## **LOS TRES AMIGOS NUMBER ONE SUBDIVISION**

APPLICATION NUMBER 1 DATE April 5, 2007

REQUEST Subdivision

# LOS TRES AMIGOS NUMBER ONE SUBDIVISION

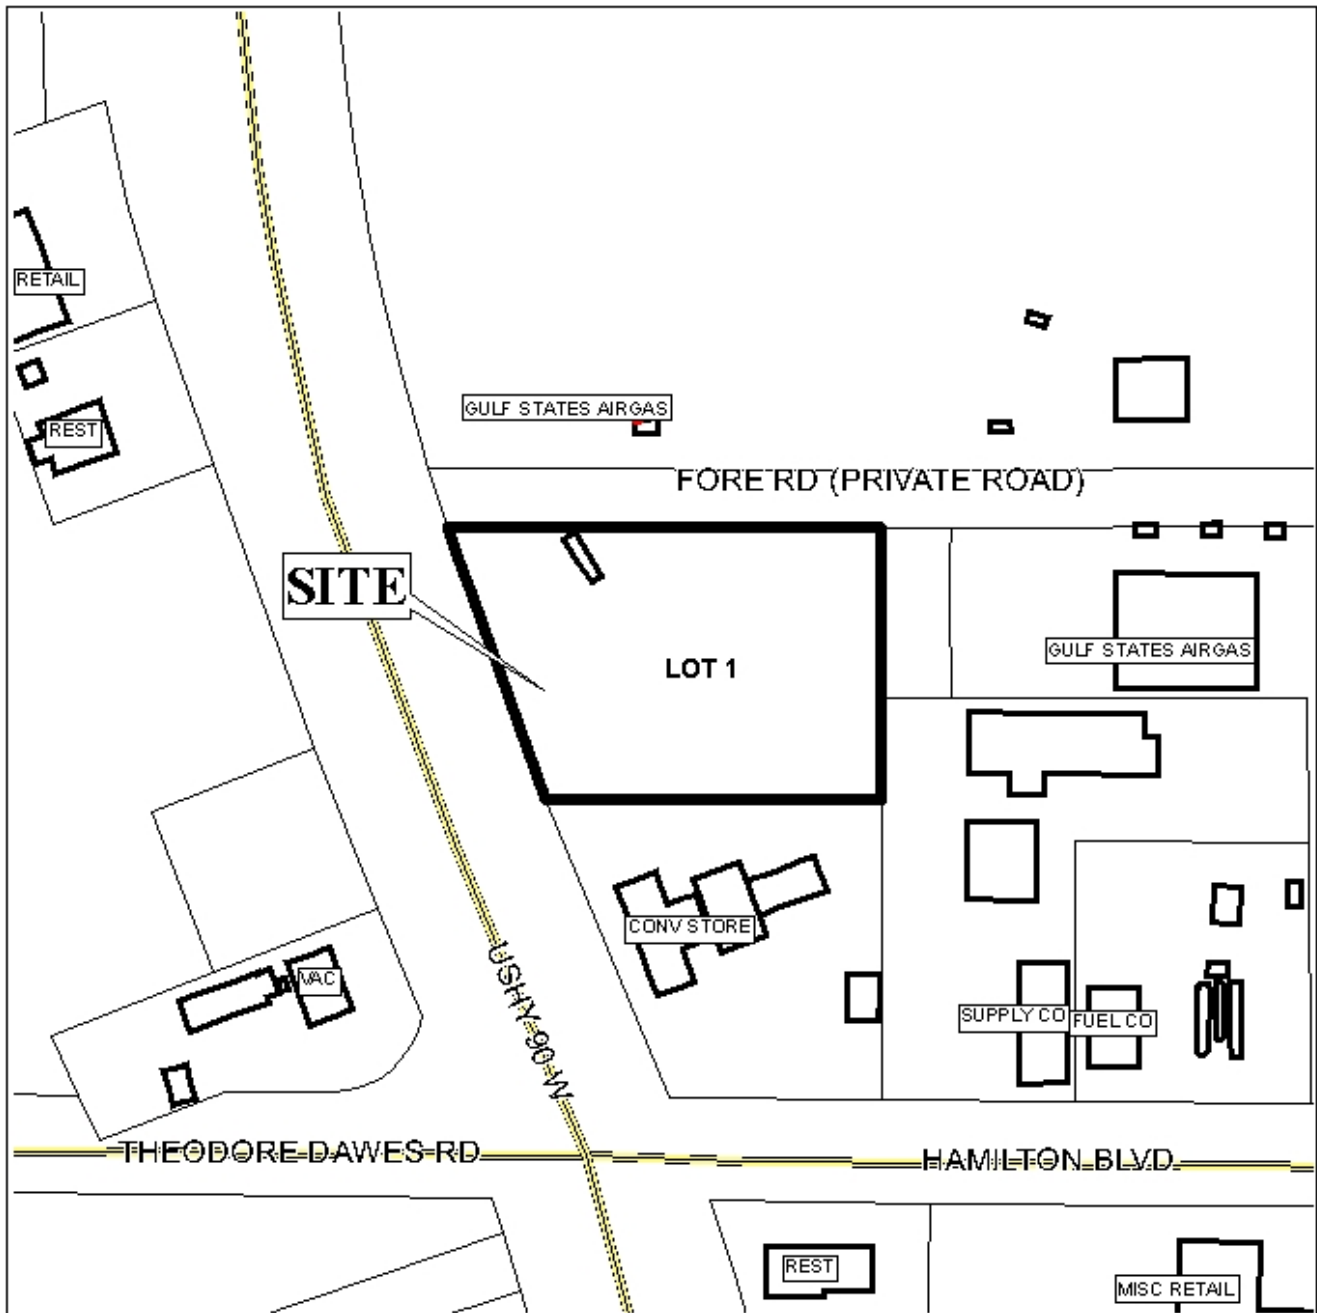
The purpose of this application is to create a 1-lot subdivision from a metes and bounds parcel. However, as illustrated on the Vicinity Map there is a land-locked parcel to the rear of the proposed preliminary plat. It appears that the land-locked parcel was created after 1984, but without going through the Subdivision process. Therefore, the parcel should be included into the proposed subdivision.

The site fronts U. S. Highway 90, which is shown as a major street on the Major Street Plan component of the Comprehensive Plan; and as such, requires a minimum right-of-way of 250-feet. The plat does not indicate the existing right-of-way width along the site. Therefore, dedication sufficient to provide a minimum of 125-feet from centerline should be required.

As U. S. Highway 90 is a major street, access management is a concern, a limitation on the number of curb cuts would be appropriate. Given the amount of linear frontage as illustrated (255-feet) and the proposed configuration, a maximum of two curb cuts, with the size, location and design to be approved by County Engineering and ALDOT should be required. Additionally, as the site is adjacent to Fore Road which is a private road access, should be denied to this private road.

The 25-foot minimum building setback lines, required in Section V.D.9., are not shown, but would be required on the final plat.

- 1) provision of documentation to show that parcel R023802032000006.005. was created prior to 1984, or inclusion of the parent parcel and subsequent divisions that occurred after 1984 as part of the Subdivision application, with additional labels and postage as necessary.

The plat is recommended for Holdover until the May 3<sup>rd</sup> meeting, with revisions due by April 9<sup>th</sup>, so that the following can be addressed:
